[Docket No. 2003-SW-10-AD; Amendment 39-14621; AD 2003-21-09 R1]

**Airworthiness Directives; Eurocopter France Model AS355E, F, F1, F2, and N Helicopters**

**ACTION:** Final rule.

Figure 1

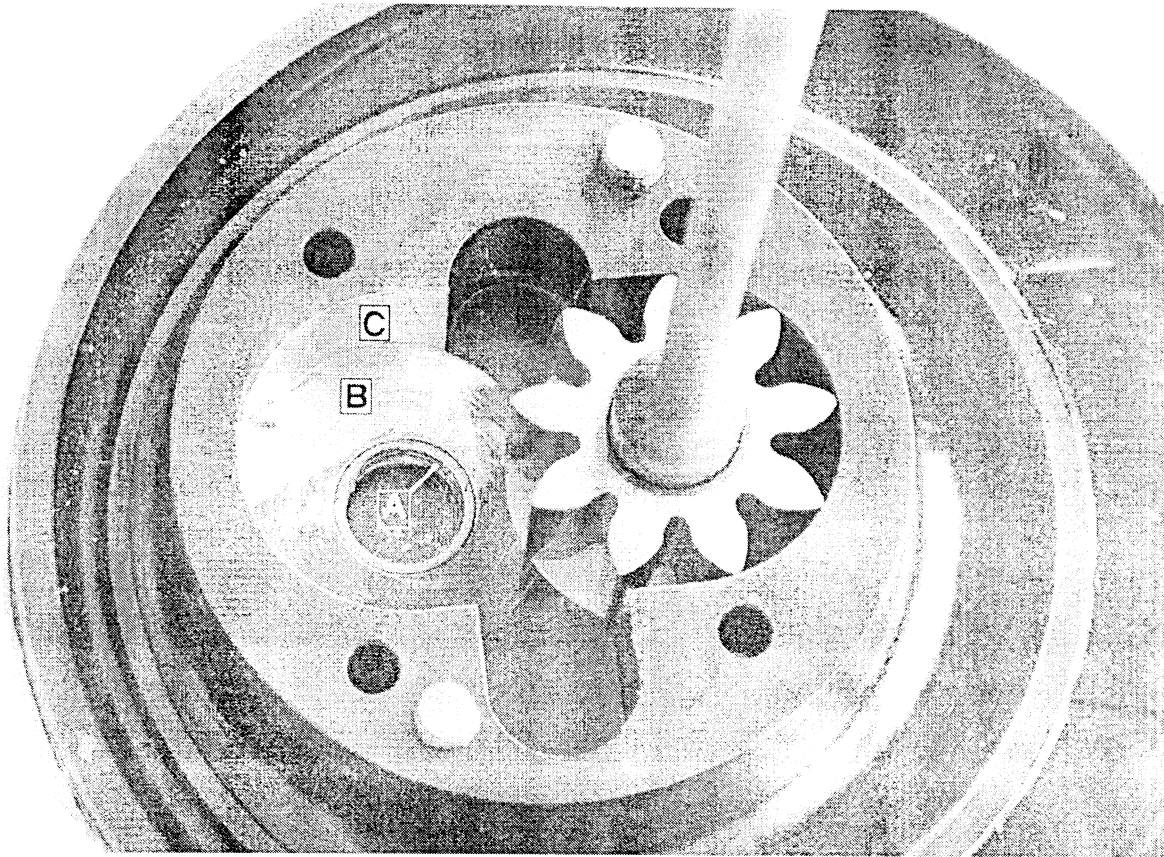
(d) While inspecting the pump, if you find any of the following, replace the MGB and the pump with an airworthy MGB and pump before further flight:

- (1) Crank pin play,
- (2) Out of round bronze bushing (A of Figure 1),
- (3) Offset of the driven gear pinion,
- (4) Metal chips, or
- (5) Wear (C of Figure 1).

**Note 2:** If wear is present in the B area only as depicted in Figure 1, replacing the MGB and the pump is not required.
